**Technische Information**

**15/2018**

**911 GT3 Cup (991) Gen.II**

**ENTFALL HALTER KRÜMMER**

**Halter Krümmer / Exhaust Manifold Bracket**

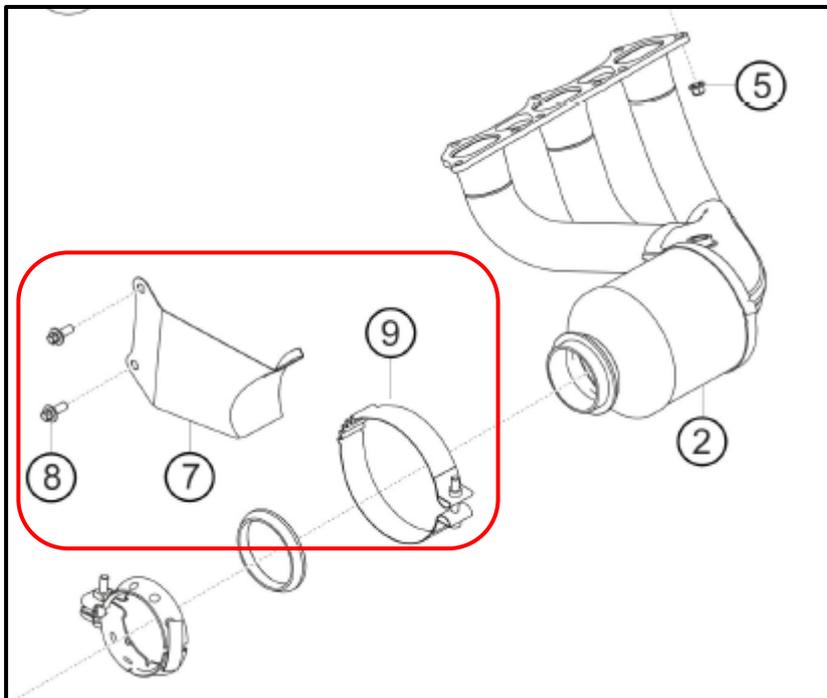
Porsche Motorsport weist darauf hin, dass der Halter des Krümmers (7), die dazugehörigen Schrauben (8) und das Spannband (9) ab sofort nicht mehr zur Befestigung des Krümmers am Motor nötig sind. Diese Bauteile sind für die Teilnahme an den Porsche Markenpokalen zu entfernen. Neue Motoren werden aus produktionstechnischen Gründen weiterhin mit Halter ausgeliefert. Auch bei neuen Motoren sind die genannten Bauteile zu entfernen.

Entfallende Bauteile:

- **9A11115479C / 9A11115489C** HALTER KRUEMMER
- **90038500102** 6RD-SHR BM 8X20
- **9A11131319A** Z SPANNBAND

Porsche Motorsport informs that the bracket (7) for the exhaust manifold, the corresponding bolts (8) and the clamp (9) are now no longer required to fasten the exhaust manifold to the engine. These components must be removed when participating in Porsche One Make Cup events. Due to manufacturing reasons, new engines will continue to be supplied with the bracket. The mentioned parts should also be removed from new engines.

Parts to be removed:

- **9A11115479C / 9A11115489C** EXHAUST MANIFOLD BRACKET
- **90038500102** TORX SCREW BM 8X20
- **9A11131319A** CLAMP
